Access Compliance Report

Public Rights-of-Way

(Pedestrian Signals)

Intersection ID: N/A	Main Street:	Cross Street: N/A	Location: N/A
ADA ID: 0E8B475D8FB7	Signal Type: Two Push Buttons-Non APS	Overall Compliance: No	Severity Score: BTN 1:N/A BTN 2: N/A No BTN: N/A
Codes/Mitigation Info/Possible Solution		Field Measurements/Component Compliance

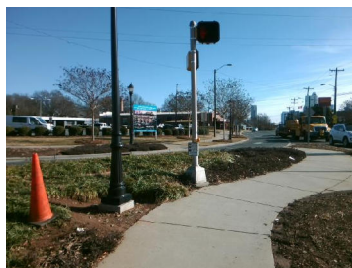
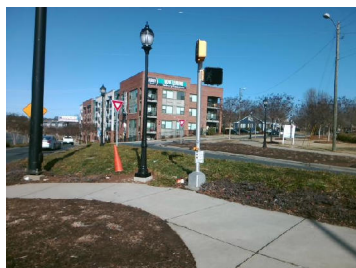
PROW/ADA: TMUTCD 4e.08, R404.2, R404.3, R404.7.2, R406.2

N/A	B 1 Clear Xing Direction?	Yes	N/A	B 2 Clear Xing Direction?	Yes
	B 1 Crossing Direction	To SE		B 2 Crossing Direction	To SW
Yes	B 1 DistanceTo XWalk (in)	0.0	Yes	B 2 DistanceTo XWalk (in)	0.0
No	B 1 DistanceTo Curb (in)	240.0	No	B 2 DistanceTo Curb (in)	220.0
Yes	B 1 Diameter (in)	2.0	Yes	B 2 Diameter (in)	2.0

Possible Solutions: Replace Signal Push Button With APS Button on New Post. Remove & Relocate Sign.
